SERVICE BULLETIN

HF-380 TRANSCEIVER (622-3580-001)
KWM-380 TRANSCEIVER (622-5093-001)
RECEIVER-EXCITER A3 (638-6908-001, -002)

SERVICE BULLETIN NO 12

CW WAVESHAPE IMPROVEMENT

P/O Receiver-Exciter Card A3
Figure 1

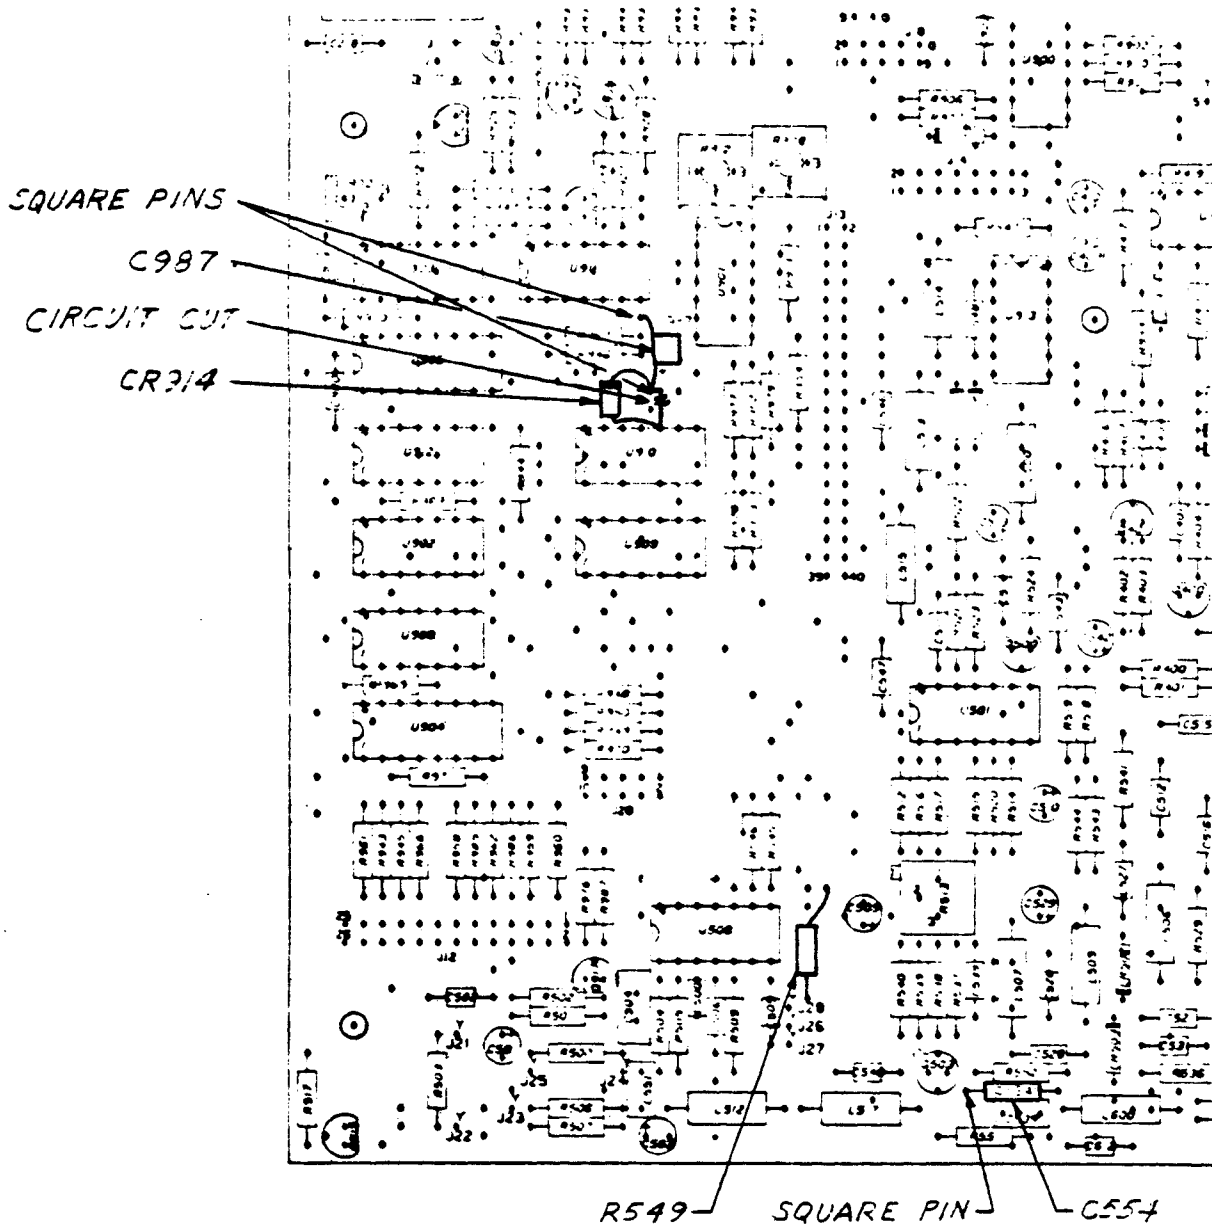
The modification consists of adding one capacitor and one diode, deleting one zener diode, two resistors, and two capacitors, and changing the value of one capacitor.

- C. Unplug ribbon cables as necessary to gain access to the areas to be modified.
- D. Unplug cable connected to J26, J27, and J28.
- E. Cut circuit trace that leads from U910-10.
- F. Insert and solder a square pin (372-2601-045) in the hole that was connected to U910-10.
- G. Insert and solder a square pin (372-2601-045) in the hole just below U911-7.
- H. Wrap the anode lead of diode CR914 (353-3644-010) around U910-10 and the cathode lead around the square pin installed in step F.
- I. Install a 0.47- μ F capacitor C987 (184-9102-330) between the square pins added in steps F and G.
- J. Remove and discard VR500, C544, C545, and R548.
- K. Remove R542 and install a square pin (372-2601-045) in the R542 hole nearest Q503.
- L. Install a 0.15- μ F capacitor C554 (913-5019-460) from the square pin installed in step K to the other hole where R542 was connected.

- M. Install 33-k Ω resistor R549 (745-0803-000) as shown in figure 1.
- N. Mark RWK REV R on the A3 circuit card near the existing REV letter.
- O. Plug the cables in that were removed in steps C and D.
- P. Reinstall the dust cover.
- Q. Mark SB 12 on the service bulletin information chart. If the transceiver does not have an information chart (280-3778-010), order one and attach it near the name-plate.

P/O Receiver-Exciter A3, Schematic Diagram
Figure 2 (Sheet 1 of 2)

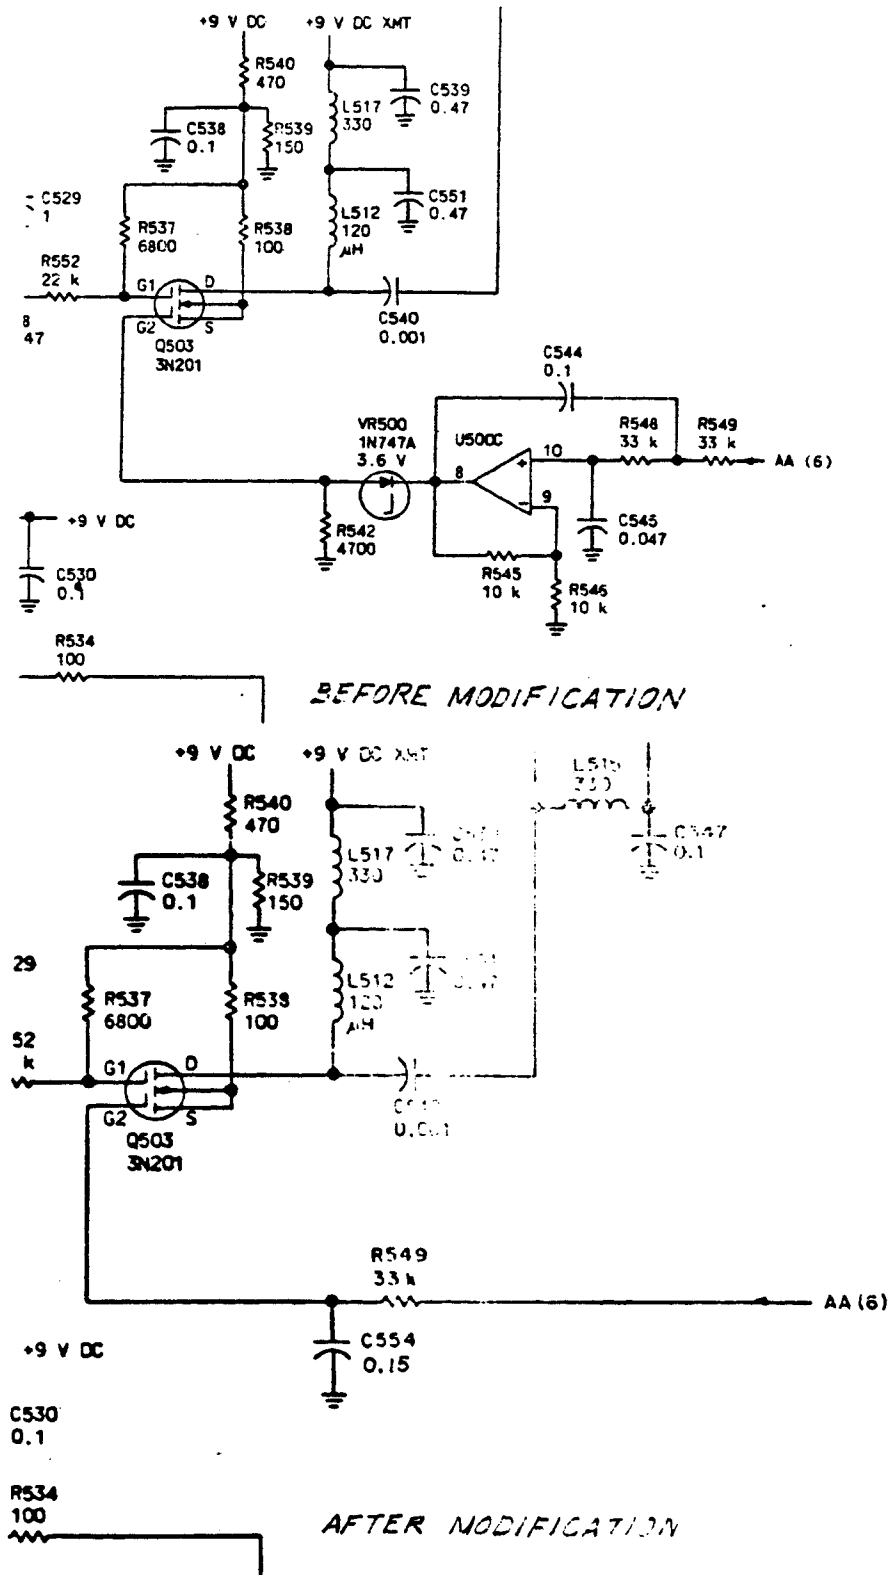
The rise and decay time of the cw envelope is less than 1 ms which may cause key clicks to be evident. This modification increases the rise and decay times to a nominal 4 ms. This still produces a hard, but click-free, waveform. This timing may be altered if desired by changing the value of R549. Increase the value to soften the keying, decrease the value to harden the keying.

NOTE: All changes are made to receiver-exciter assembly A3, located on the bottom of the unit. Taking care to not damage adjacent components, these modifications can be made without removing A3 from the chassis. Refer to Receiver-Exciter A3 instructions in the circuit cards section located in the back of the HF-380 and KWM-380 service manuals for location of components to be removed. Refer to figure 1 of this bulletin for location of added components. Refer to figure 2 for a schematic diagram which includes the changes made by this modification.
